THE GLIDING FEDERATION OF AUSTRALIA

GFA AD 510
(ISSUE 1)

- TYPE AFFECTED:** LS 4 and LS 4-a, S/N 4000 to 4852.
- SUBJECT:** Air brake locking in fuselage.
- BACKGROUND:** Due to possibly improper preflight checks, asymmetric adjustment of pushrods during exchange of L'Hotellier ball snap joints or uneven locking adjustments, the airbrake locking bracket may be under long time asymmetric load, resulting in fatigue fracture at the lateral fixtures.

Subject: Air brake locking in fuselage

Air brake locking bracket on landing gear box (Crack region marked)

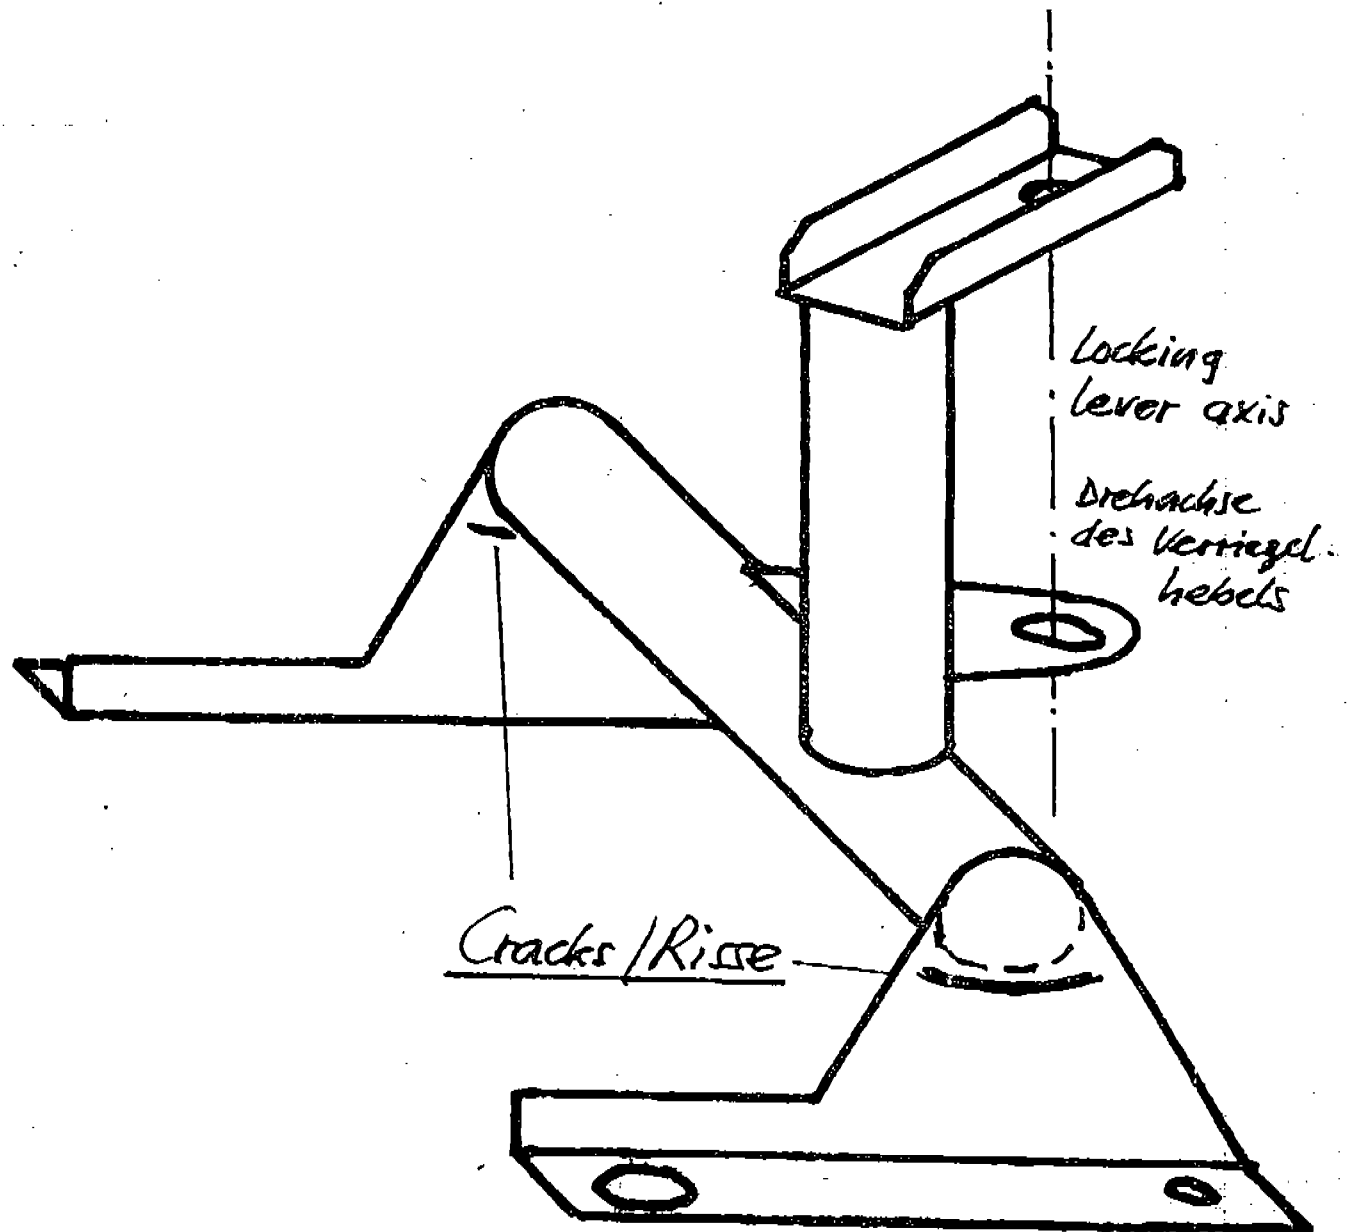
2. Check both fixing angles at this air brake locking bracket for lateral deformation (indication by cracks in paint or paint chipping off) and/or cracks in the welding area next to the tube. See sketch of air brake locking bracket.

- Material and Instructions:
1. With sailplane rigged, check air brake locking bracket on rear landing gear box for lateral movement during air brake locking.
 2. Check both fixing angles at this air brake locking bracket for lateral deformation (indication by cracks in paint or paint chipping off) and/or cracks in the welding region to the tube. (See sketch on page 2)
 3. Only with cracks or deformation existent, disassemble the bracket. Repair and modification required according to drawing 3R6-27b.

3. When cracks or deformation are detected disassemble the bracket. Repair and modification is required according to Technical Bulletin No. 4042.
- WEIGHT AND BALANCE:** Not affected.
